ULNRC-05242

**DOCKET NUMBER 50-483  
CALLAWAY PLANT UNIT 1  
UNION ELECTRIC CO.  
FACILITY OPERATING LICENSE NPF-30  
RESPONSE TO REQUEST FOR ADDITIONAL INFORMATION REACTOR  
COOLANT SYSTEM LEAKAGE DETECTION INSTRUMENTATION**

## RESPONSES TO REQUEST FOR ADDITIONAL INFORMATION

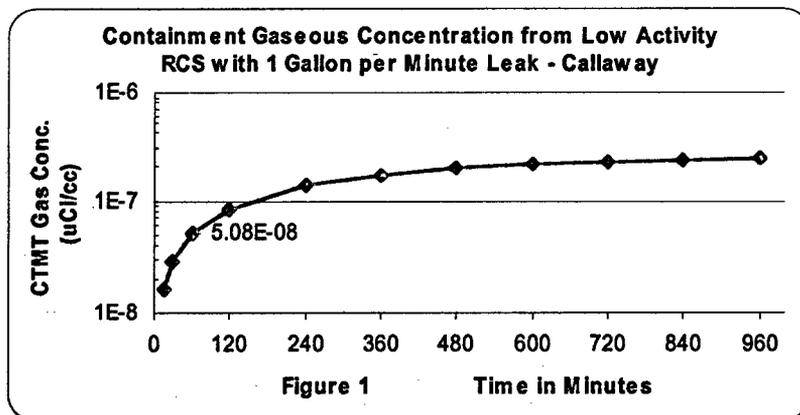
1. Given the discussion in the application on the containment atmosphere (gaseous) radioactivity monitor not being able to detect 1 gpm reactor coolant leakage in any way close to 1 hour for the current normal radioactivity levels in the reactor coolant, explain why this monitor is being retained in Limiting Condition for Operation (LCO) 3.4.15.

An evaluation performed in 2003 using current RCS activity levels resulted in a containment gaseous concentration at the end of 60 minutes to be  $\sim 5.1E-08 \mu\text{Ci}/\text{cm}^3$  (see Figure 1 below). This evaluation confirmed the insensitivity of the containment atmosphere gaseous channels to low RCS activity.
